Work Order ID 89184

Item Name: Crosstube Aft

DART AEROSPACE LTD		Work Order:	89184
Description: Crosstube High Aft (412)		Part Number:	D412-664-203
Inspection Dwg: D412-664-243 Rev: E		Page 1 of 1

DRAWING NO. D412-664-243	TITLE CROSSTUBE ASSEMBLY (412 HI AFT)	REV. E	DART AEROSPACE LTD ENGINEERING ORDER		D.E.O. NO. D412-664-243-E-1	SHEET NO. SHEET 1 OF 2	SCALE NTS
DRAWN	CHECKED	MFG. APPR.	APPROVED		DE APPR.		
DATE 11.03.31	DATE 11/03/31	DATE 11.03.31	DATE 11/03/31		DATE 11.03.31

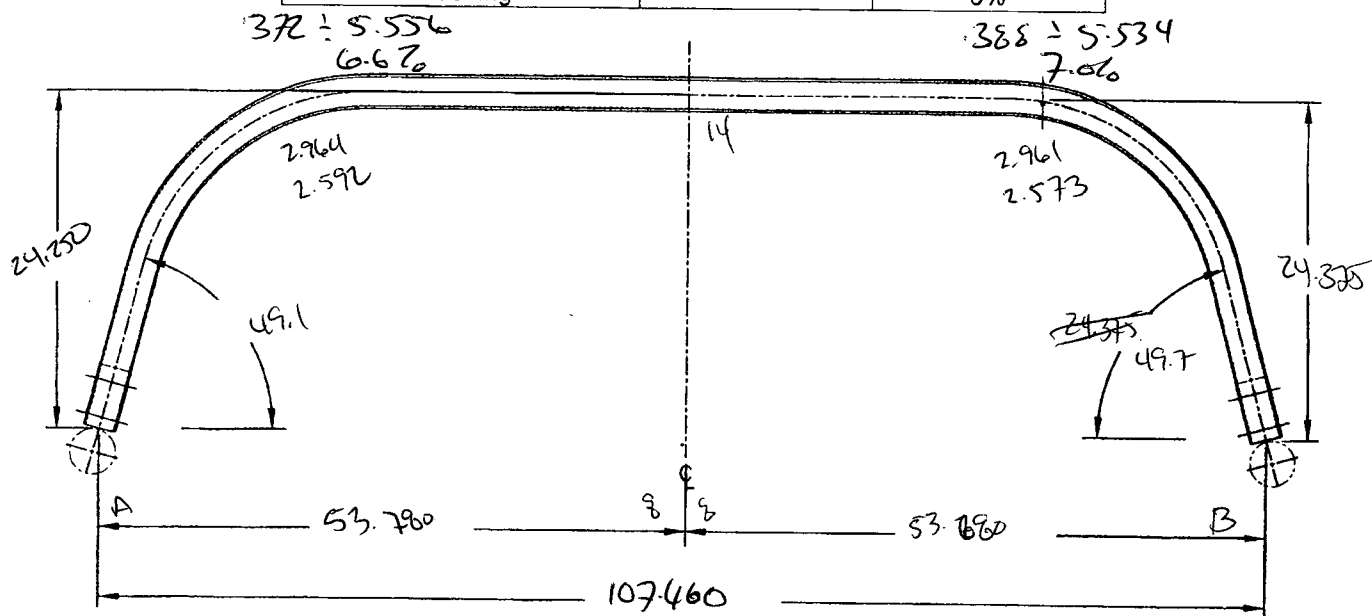
Side A	Middle	Side B
Bending Passes	8	14	8
Crushing	6.67%		7.0%
Comments			
Side A = 6.67% @ 8 Passes			
Middle = 14 Passes			
Side B = 7.0% @ 8 Passes

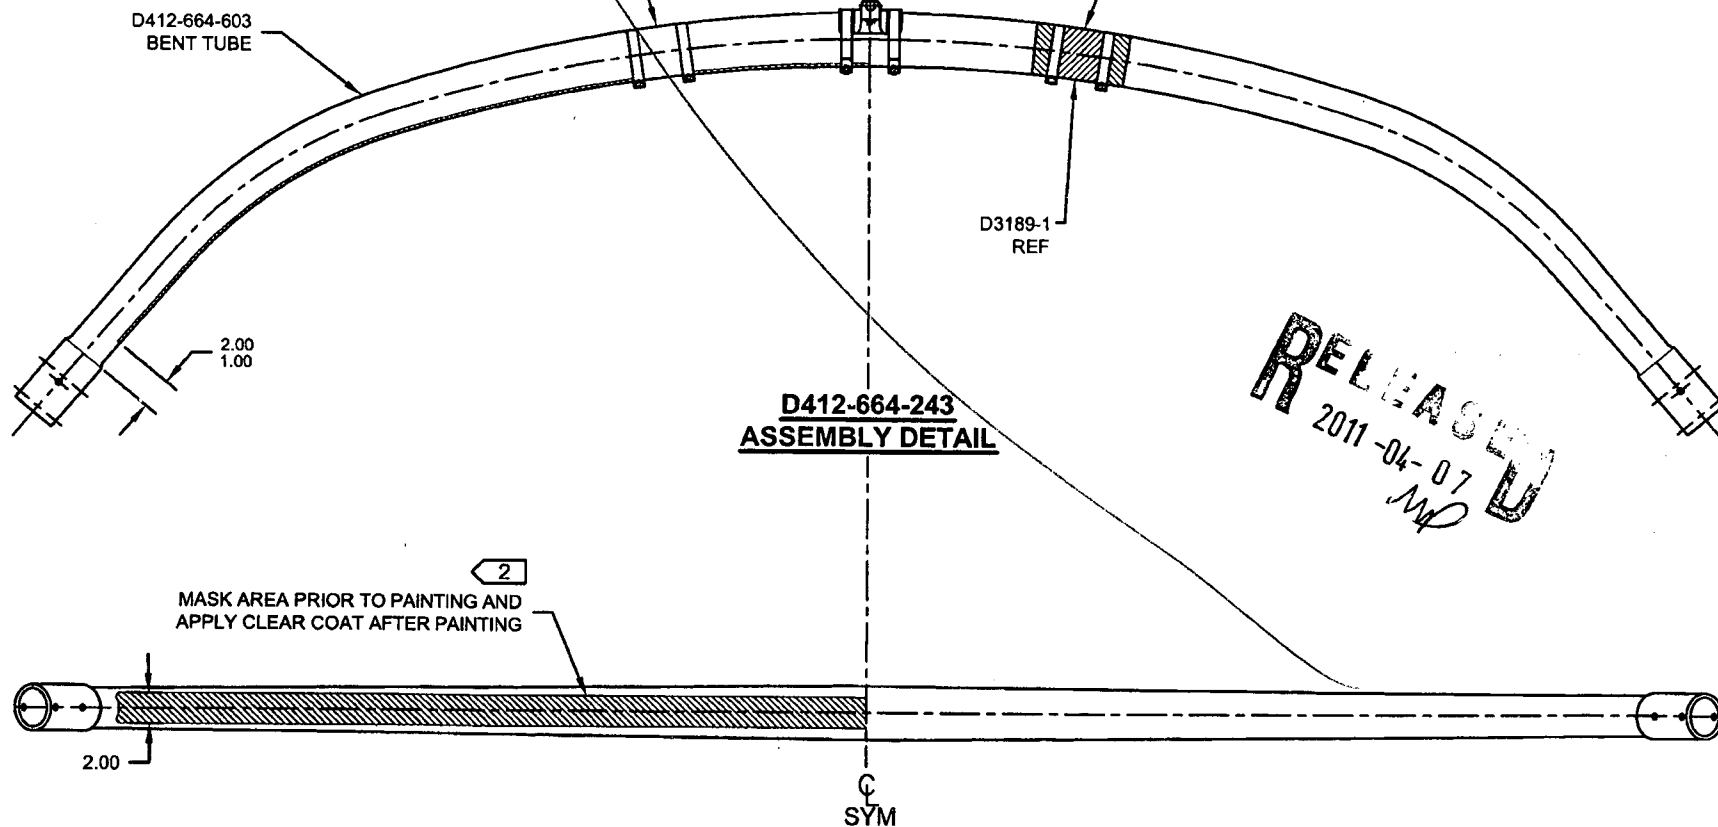
IS:

D3189-1 CHAFING SHIELD (1, INSTALLED OVER PROSEAL 890)
MS21920-28 CLAMP, 2X
2 PL

WAS:

D2856-600-1009 ABRASION STRIP
D3189-1 CHAFING SHIELD (1, INSTALLED OVER ABRASION STRIP)
MS21920-28 CLAMP, 2X
2 PL

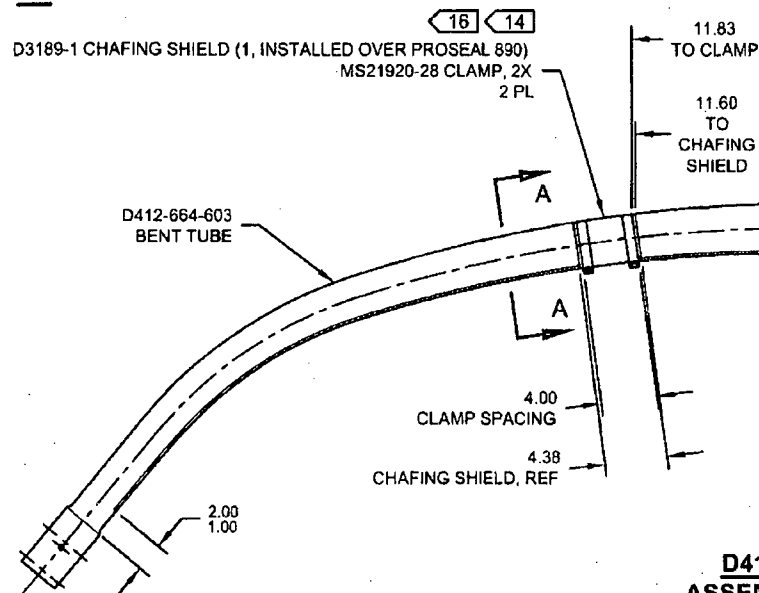
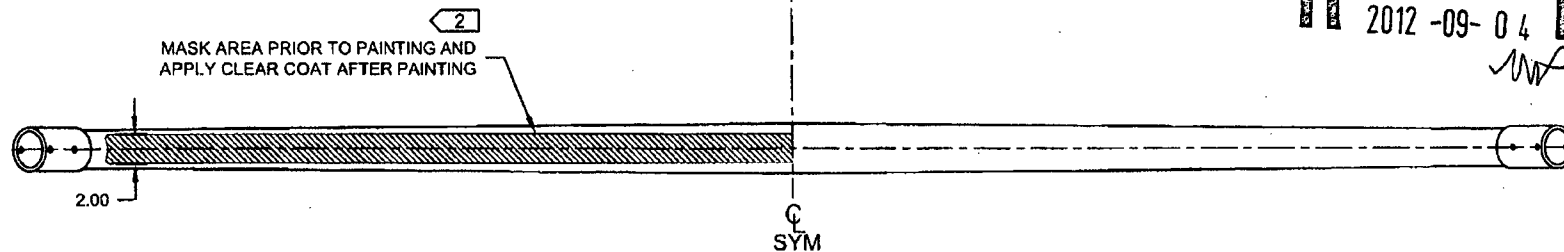
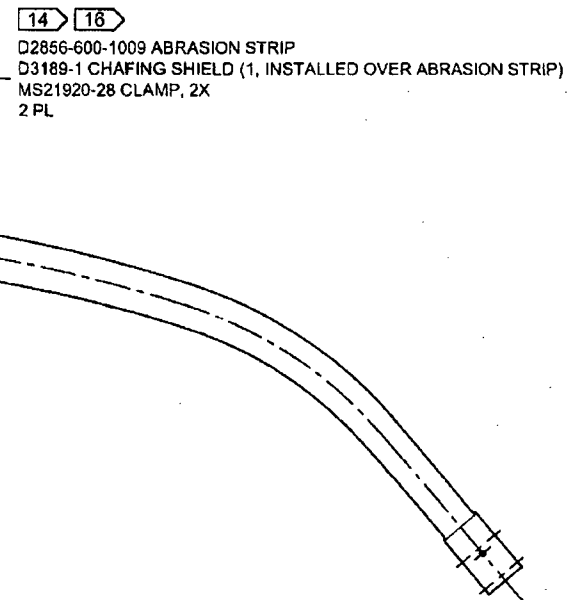
REMOVED ABRASION STRIP IN FAVOR OF A THIN LAYER OF PROSEAL 890. UPDATE INSTALLATION OF CHAFING SHIELDS AND REDUCE TORQUE TO 40-50 IN-LBS. THIS ENGINEERING ORDER SUPERCEDES DEO D412-664-243-E-1.

IS:

WAS:

CRUSHING OF D412-664-243

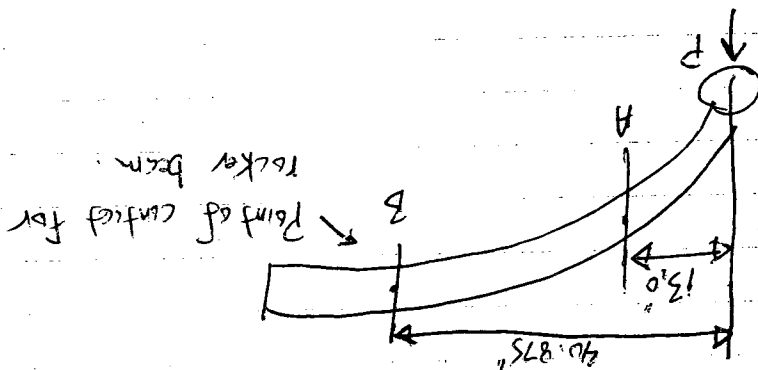
Acceptability of 8% CRUSHING AT END OF BEND

Point A: $W_1 = 2.961$, $W_2 = 2.522$
 $CRUSHING = (2.961 - 2.522) / (2.961 + 2.522) = 8\%$

Point B: $W_1 = 3.307$, $I = 4.613 \text{ in}^4$
 $I = 1.676 \text{ in}^4$ (from AutoCAD)

A: $F = M_c / I = P \times 13 \times 2.961 / 2 \times 1.676 = 11.484 \cdot P$
 B: $" = P \times 40.875 \times 3.307 / 2 \times 4.613 = 14.651 \cdot P$

M.S. = $14.651 / 11.484 - 1 = 0.27$

∴ Tube will break at rocker beam contact before cross of 8% crushing! 8% crushing in cross at end of tube
 bend is acceptable
